IEEE802.3bt
LLDP adhoc

Meeting #6: Tuesday August 1, 2017

- **The purpose** of this ad-hoc is to resolve LLDP state machine related comments from D2.4 and related issues for PSE and PDs prior sponsor ballot for D3.0.

- Argument #3

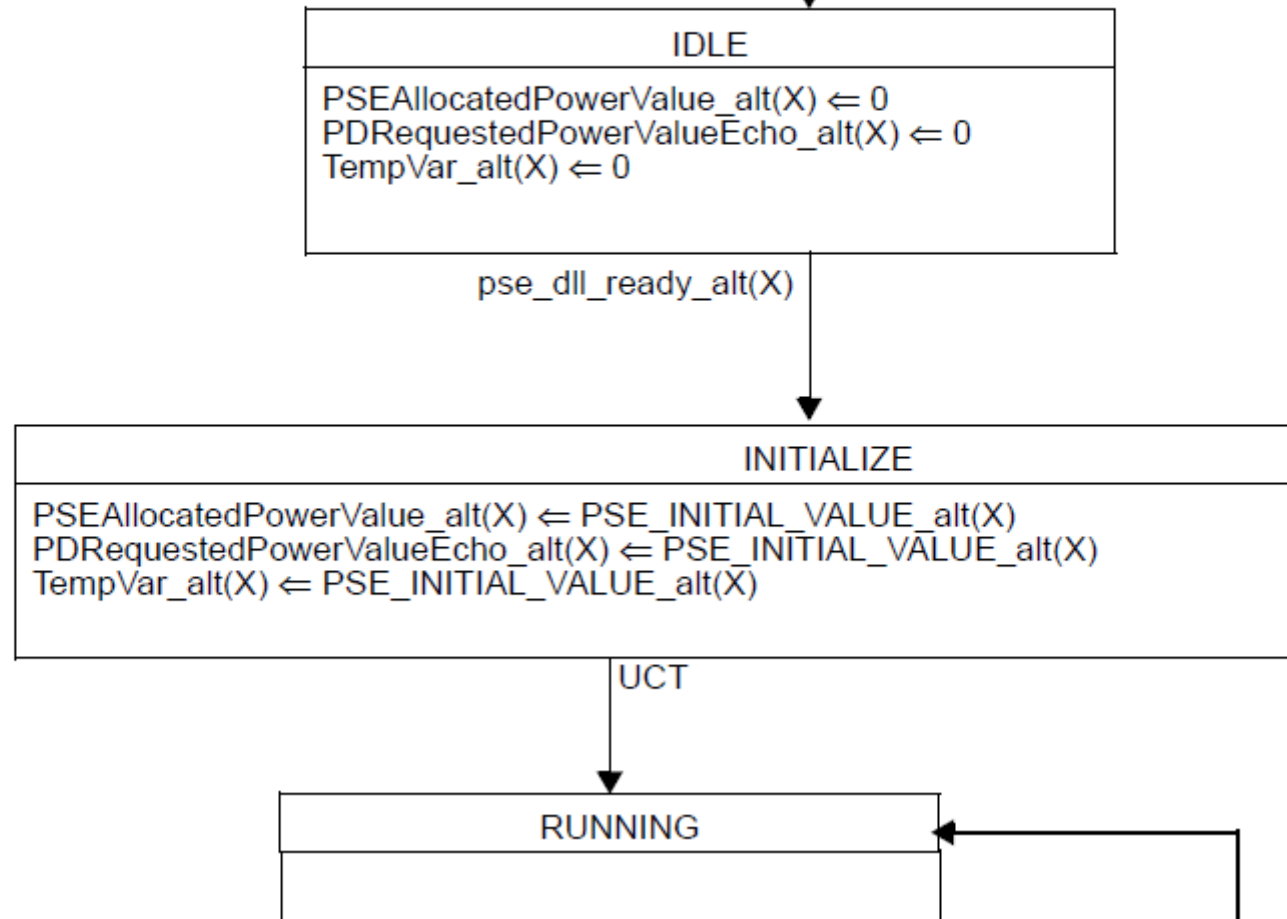
High level power management care only for the total port power. The power management per pairset is kind of sublayer of the power management system. It is useful to pass the total power through the TLVs field. This is in general how current PSEs systems works.

Other alternative solution to this problem is to use the field “PSE max available power” which should be the total port power. We need to clarify in 79.3.2.6e that this value is applicable for PSE that supports single-signature and dual-signature.

Annex B: Comment #297 D2.4 (Page 75 line 12 in D2.5) - Figure 145-44
 Proposal for a change marked in RED. Group is OK.

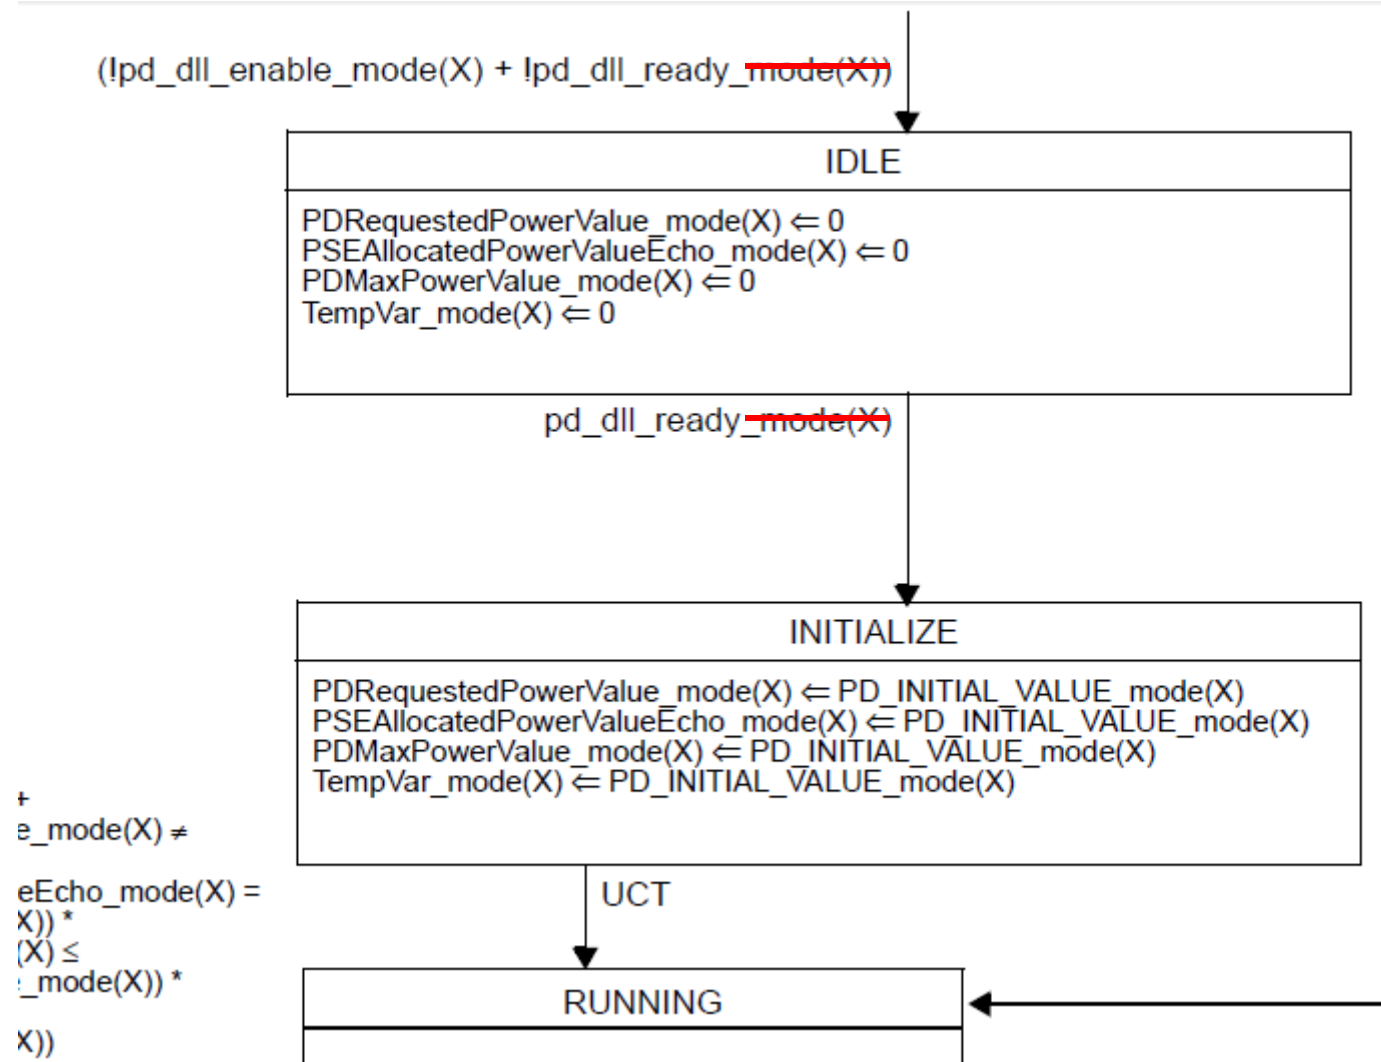
Annex B: Comment #297 D2.4 (Page 75 line 12 in D2.5) - Figure 145-43

$(!pse_dll_enable_alt(X) + !pse_dll_ready_alt(X)) * (sig_type = dual)$

- We have the information of total available power in the field “PSE maximum available power” in 79.3.2.6e. This resolve argument #2 in Annex A.
- To resolve #297, Lennart suggests: In order to request power on the unpowered pairset, see proposed changes in the red text. In addition, the `pd_dll_ready_mode(X)` need to be changed to `pd_dll_ready` to allow progressing to the INITIALIZE state in case PD want power on the unpowered pairset. No changes required in the PSE portion.

- Yair it will work:
- The proposal is:
 - To change from `pd_dll_ready_mode(X)` to `pd_dll_ready` in the PD state machine.
 - To change “if this mode/Alt is inactive, set to value 0” to “if this Alt is inactive, set to value 0” i.e. keep this requirement only to PSE.

- Group is OK.
